CSA Project No: SMC6280A

SUBJECT: **Supplemental Engineering Geologic Peer Review**

RE: Mukaeda; New Residence on a Vacant Lot
PLN2020-00070
APN 037-221-020
"0" Cypress Avenue

COTTON, SHIRES AND ASSOCIATES, INC. CONSULTING ENGINEERS AND GEOLOGISTS		
2016 LIDAR PROFILE/1997 SIMPSON OVERLAY "0" Cypress Avenue SAN MATEO COUNTY, CALIFORNIA		
GEO/ENG BY CS/AM	SCALE 1"=10'	PROJECT NO. SMC6280
APPROVED BY DTS	DATE April 2022	FIGURE NO. 2

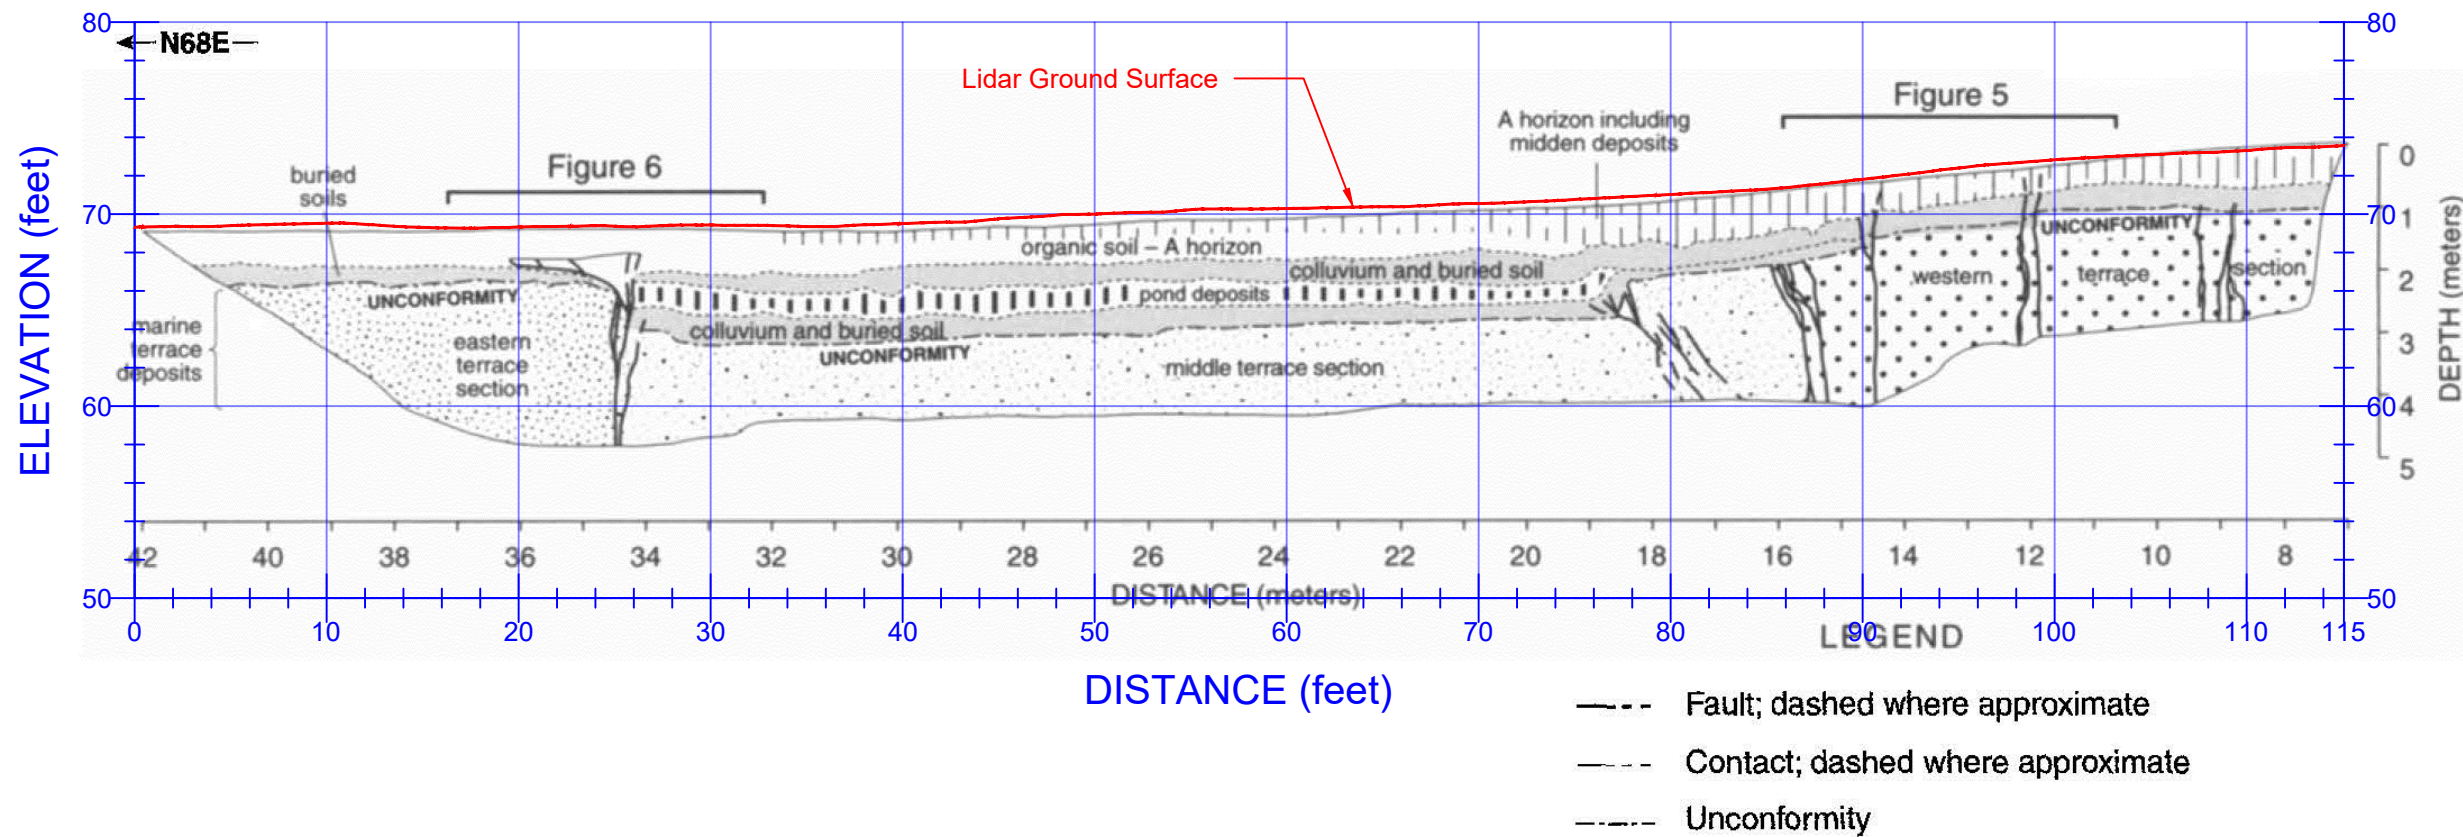
We also find that active faulting described in the trench north of the site has not been adequately considered in the supplemental analysis and discussion provided by the Project Geologist. Specifically, the approximately 0.5-foot to 1.5-foot-wide trace oriented N34W at station F34.5 of the Simpson (1997) trench which we understand was also encountered in an additional trench north of the Simpson study per Figure 3 of the 1997 report.

To further aide in the evaluation of surface fault rupture at the subject site we performed a limited analysis intended to better locate the Simpson 1997 trench for review by the Project Geologist (SPG). Utilizing the publicly available LiDAR data set "2016 USGS West Coast El-Nino LiDAR DEM" as a base map, we identified distinct topographic features (mounds) that appear on both the 2016 LiDAR and on Figure 3 of the Simpson report (see Figure 1). We plotted contour intervals (0.656 feet minor and 3.28 feet major) to match those included on Figure 3 of the Simpson report, which provides measurements and scales in meters and uses a 1-meter major contour interval and a 0.2-meter minor contour interval. To confirm whether our georeferencing of the 1997 trench location was reasonable we plotted a topographic profile utilizing the 2016 LiDAR data in relation to the trench log profile (see Figure 2). We note that based on our georeferencing of Figure 3 of the Simpson 1997 report we believe that north is slightly misoriented as published. We also include a straight line extending south from the trench and fault trace location identified in the Simpson report, and oriented N34W as measured in the Simpson report.

Consequently, we find that conclusions and analysis provided for our peer review are incomplete and we recommend the Project Geologist consider the likelihood that the fault trace logged on the western side of the subject property represents a through-going active fault zone associated with the Seal Cove Fault.
